ADDENDUM #4

**PROJECT: RENOVATIONS TO THE SCOTLANDVILLE BRANCH LIBRARY - PHASE II
CITY PARISH PROJECT NO. 21-ASC-CP-1449**

ADDENDUM Attachment to City Parish Addendum 4
January 27, 2025

RE: **Renovations to Scotlandville Branch Library – Phase 2**
EBR Project # 21-ASC-CP-1449

01
 BASE BID WITH EXISTING CANOPY ENLARGED SITE PLAN
 1/4" = 1'-0" BASE BID
 (NOTE: SEE SHEET A4 FOR THIS PLAN IN ALTERNATE #1)
 TRUE NORTH PLAN NORTH

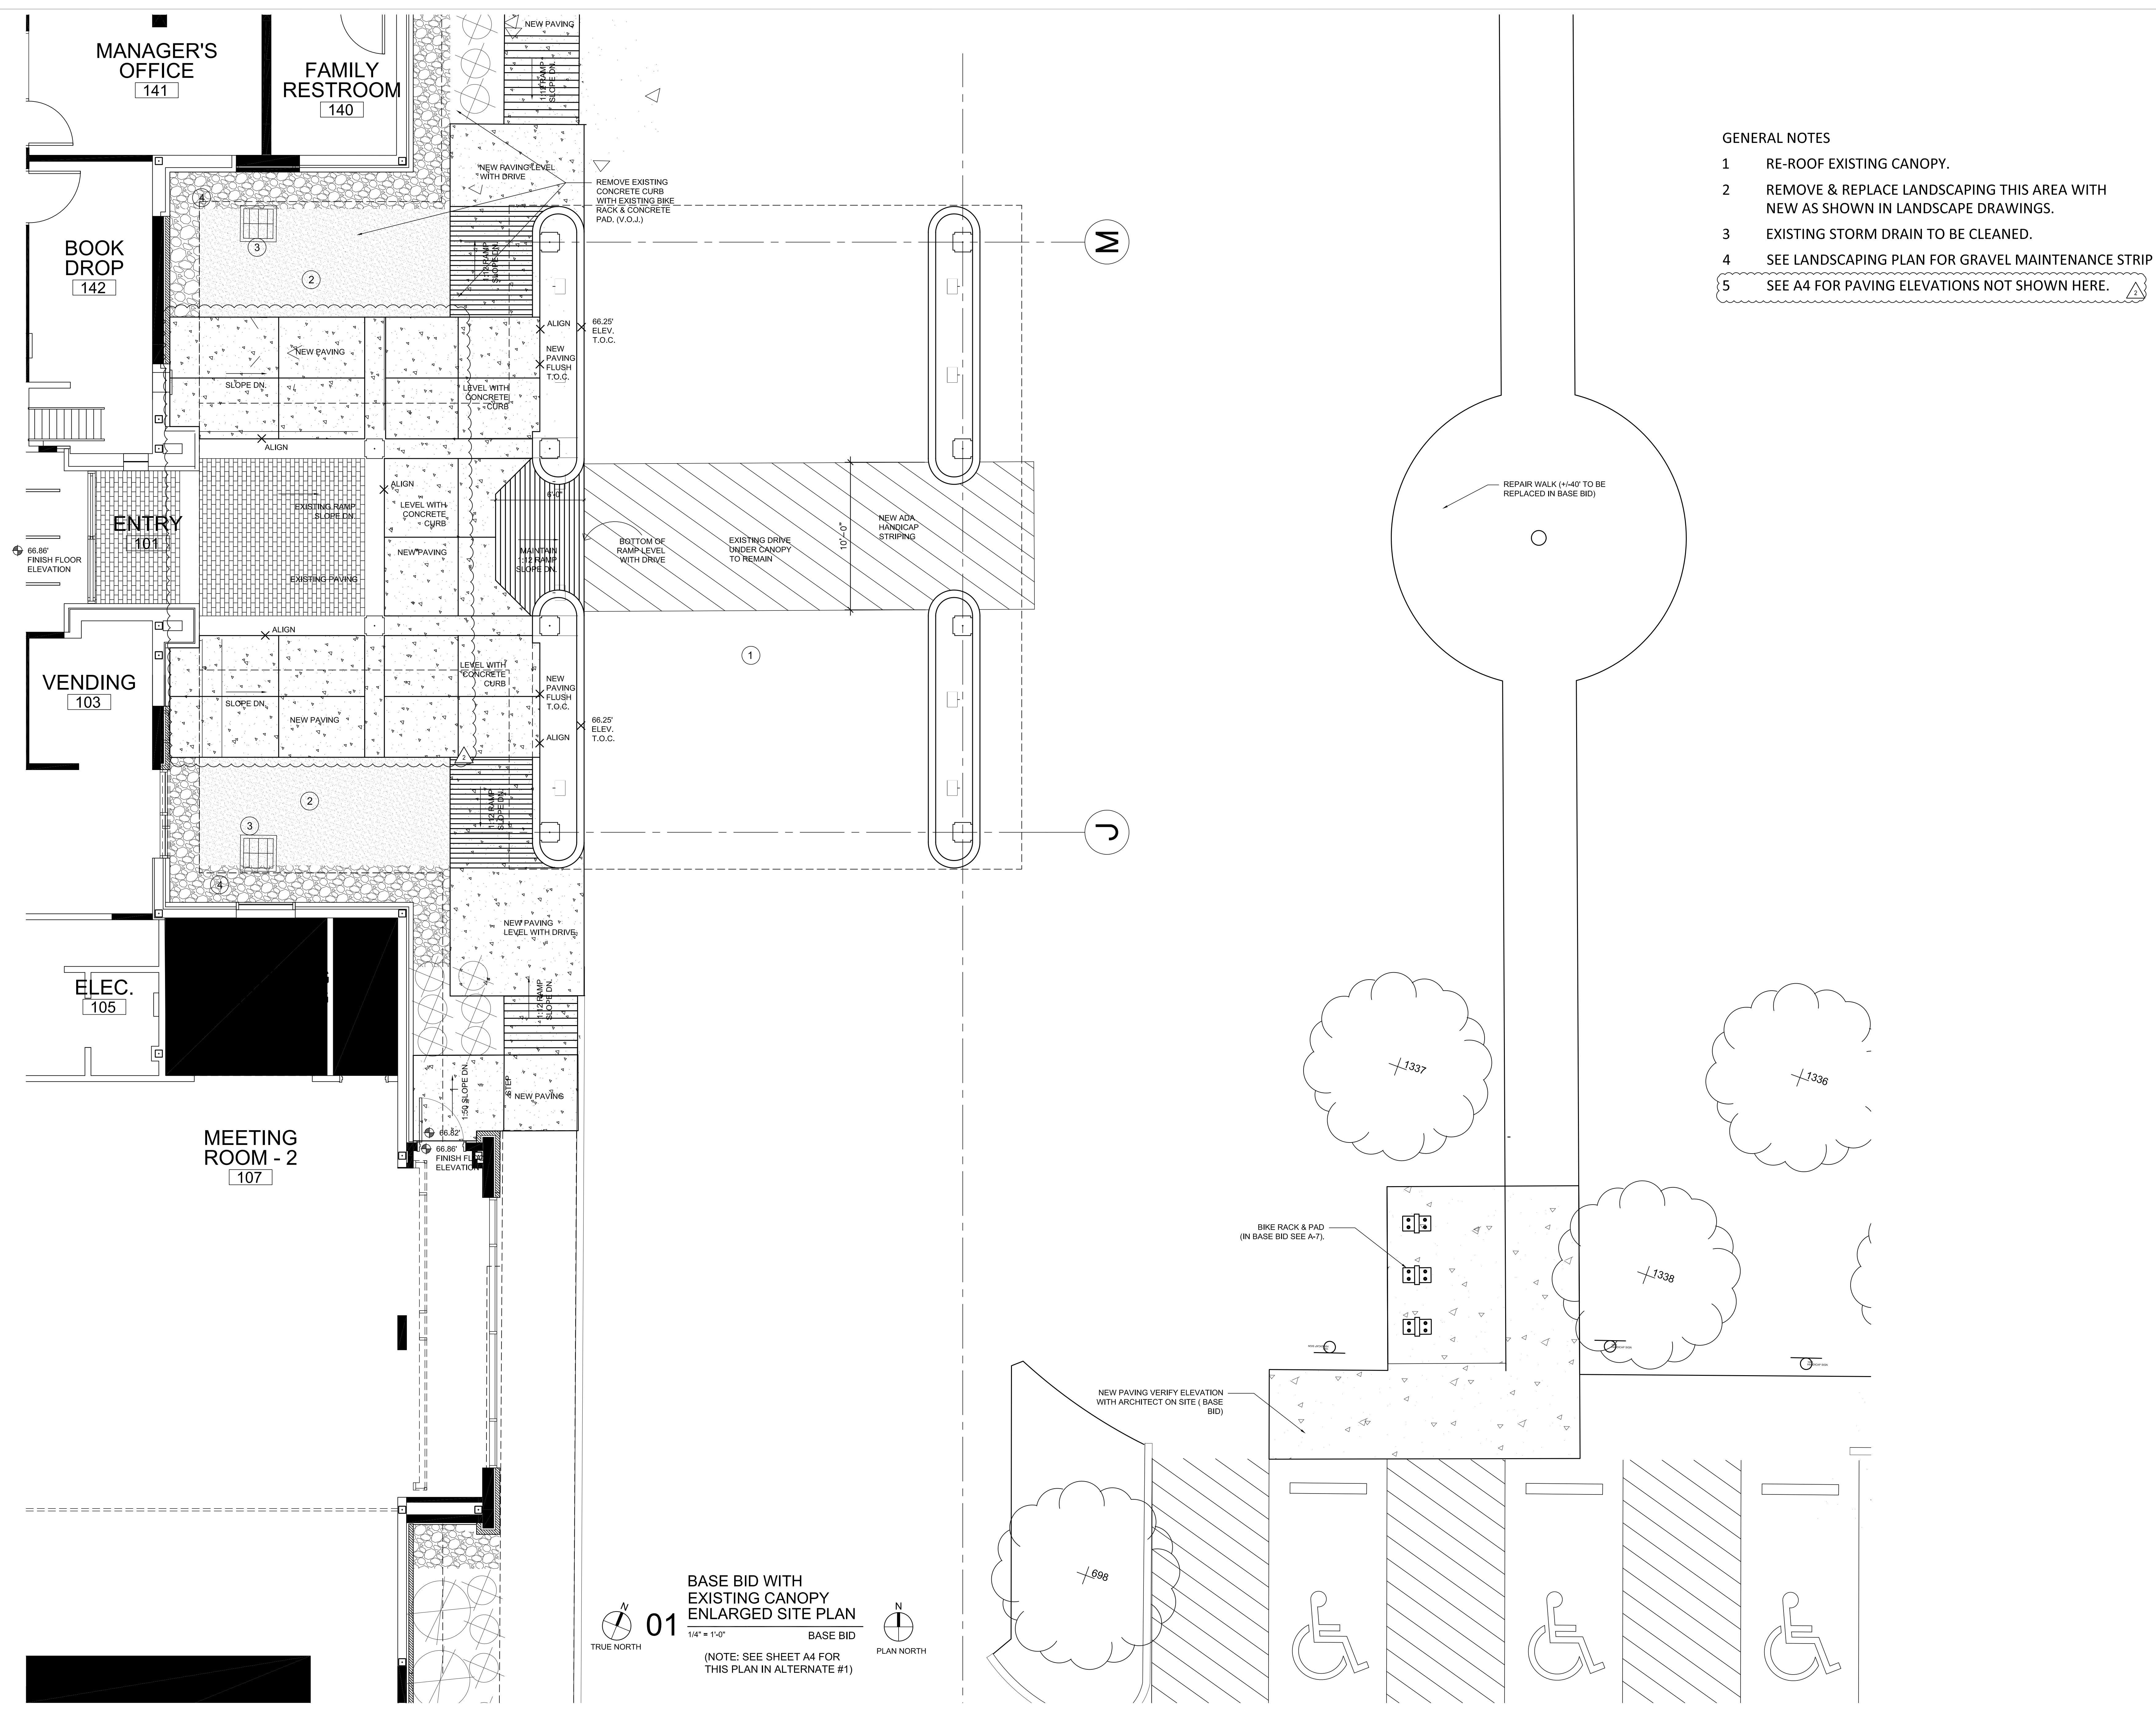
A9 – Base Bid Entrance Plan corrected.

01 BASE BID - EXTERIOR ELEVATION - EAST
1/8" = 1'-0"

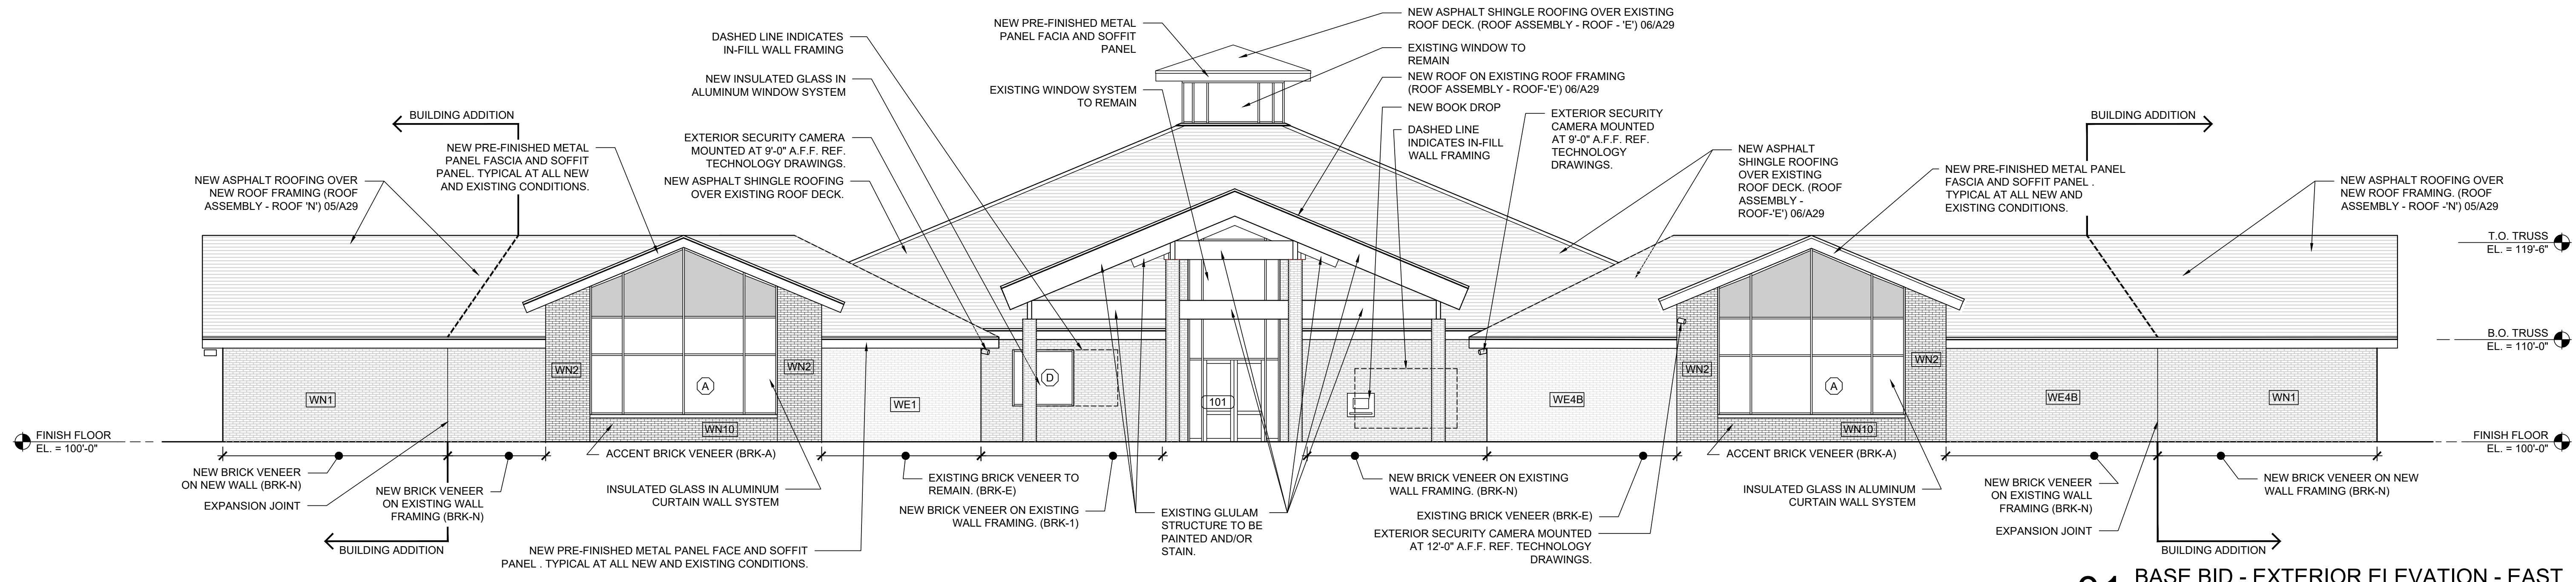
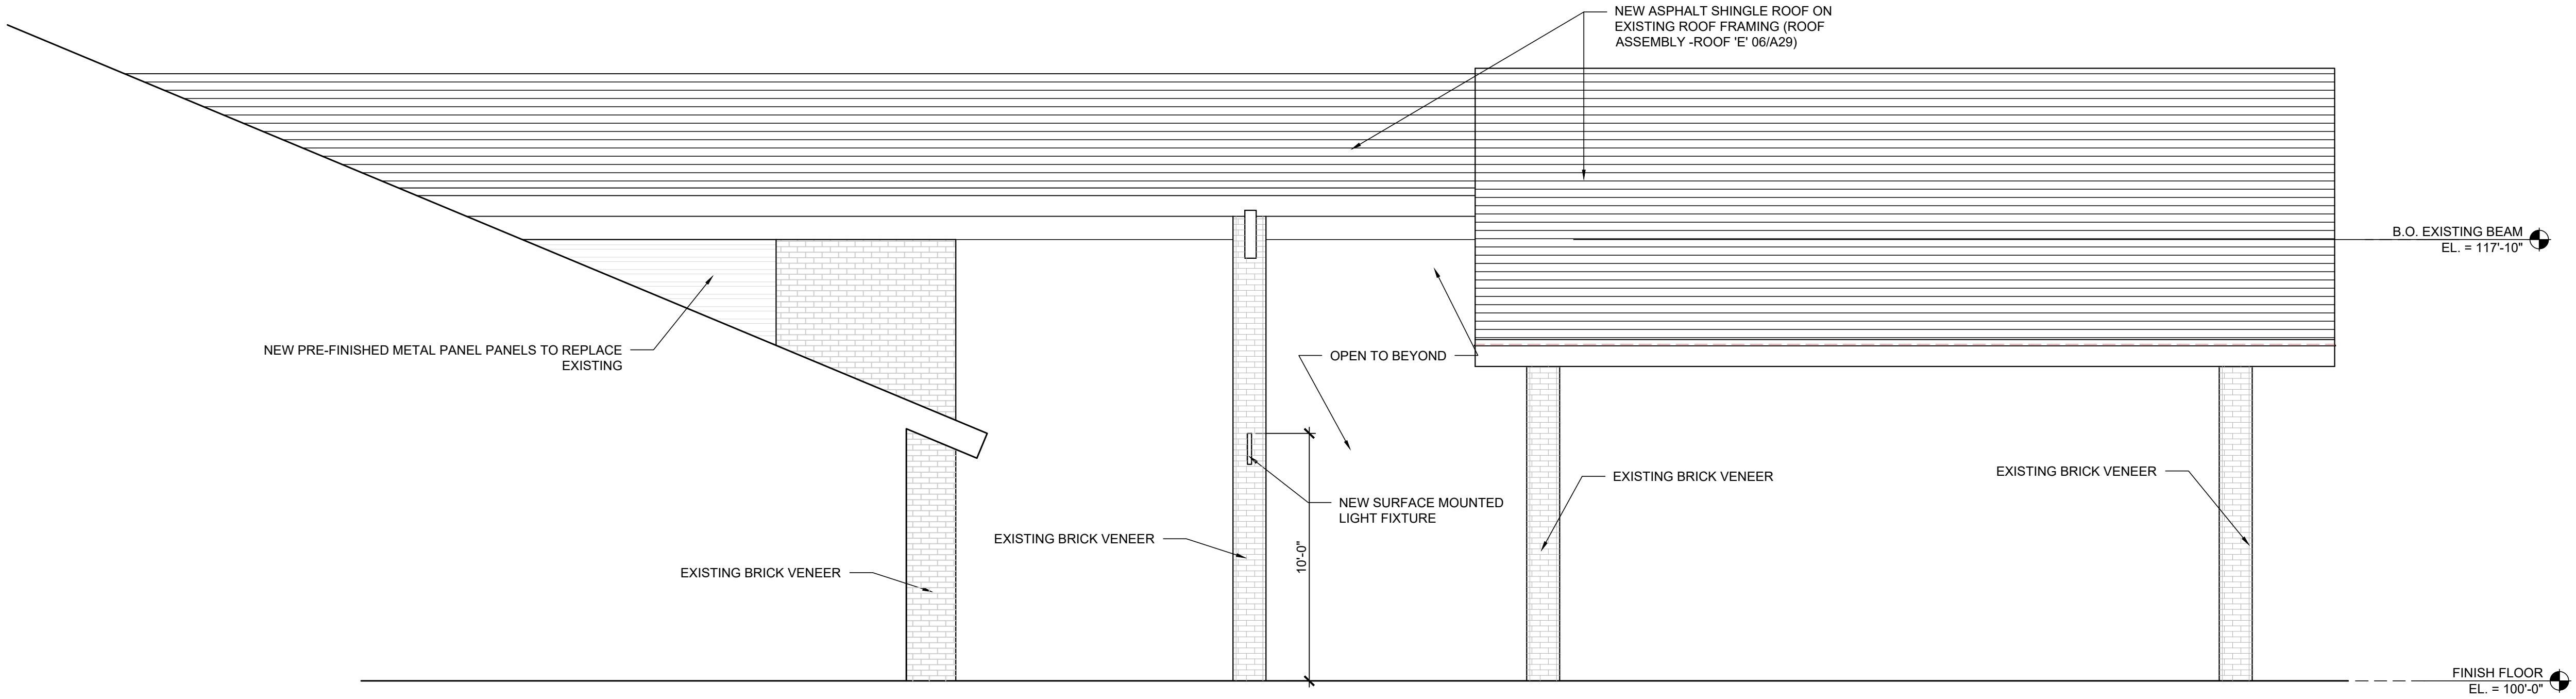
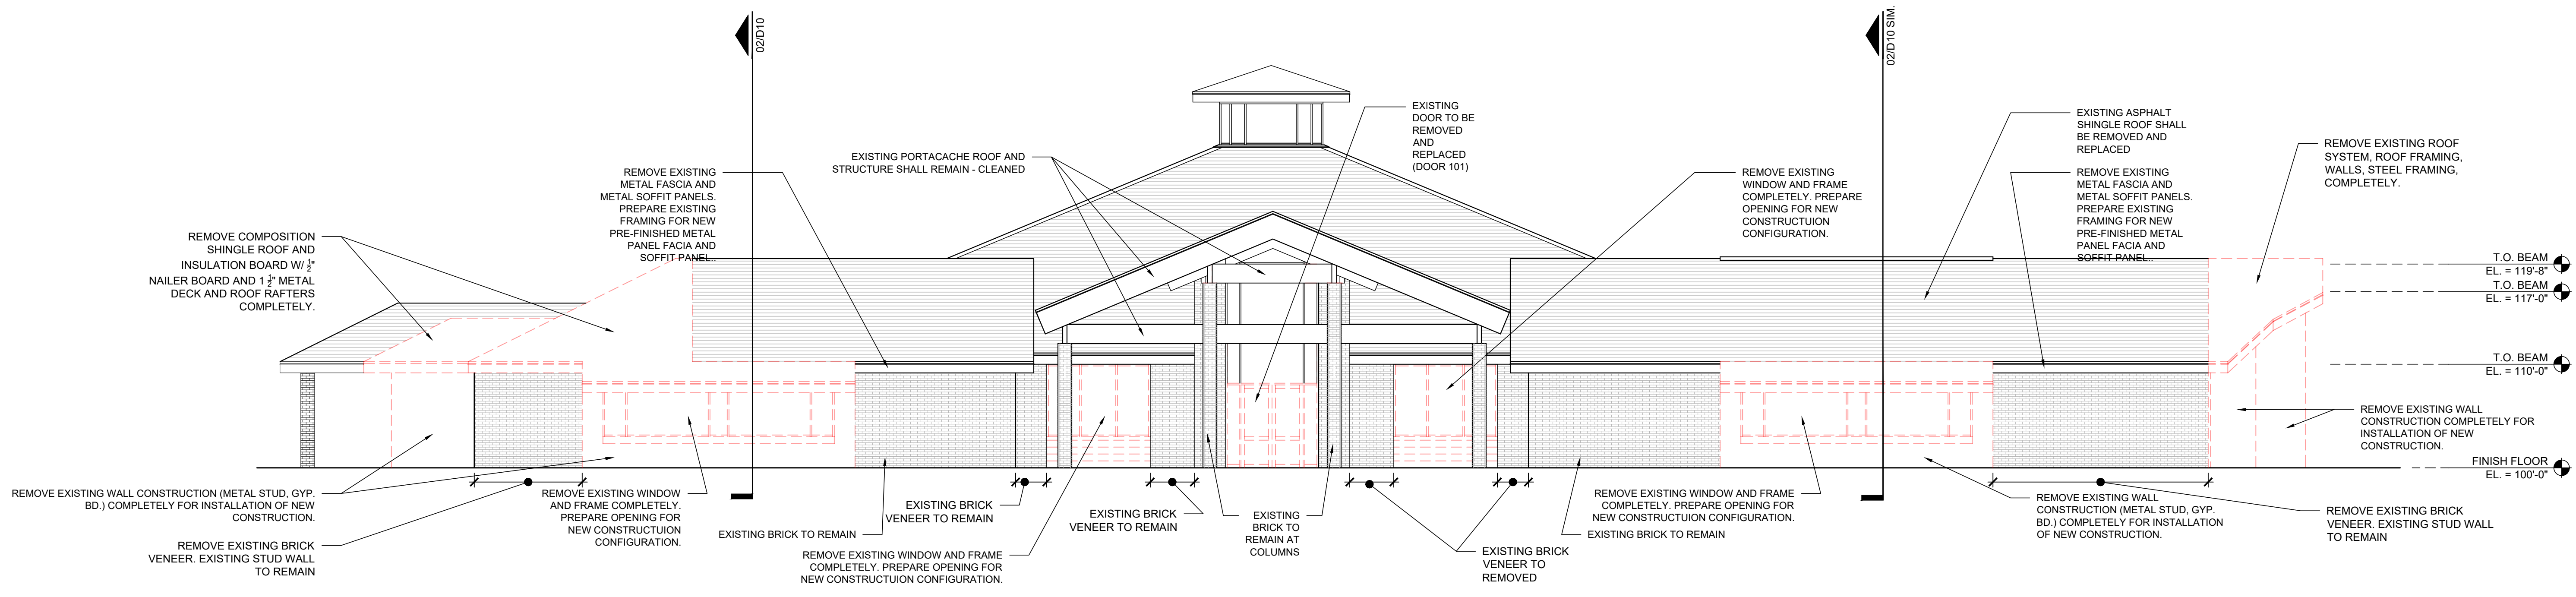
A14B – Added sheet which indicates the Exterior Elevation Base Bid Configuration.
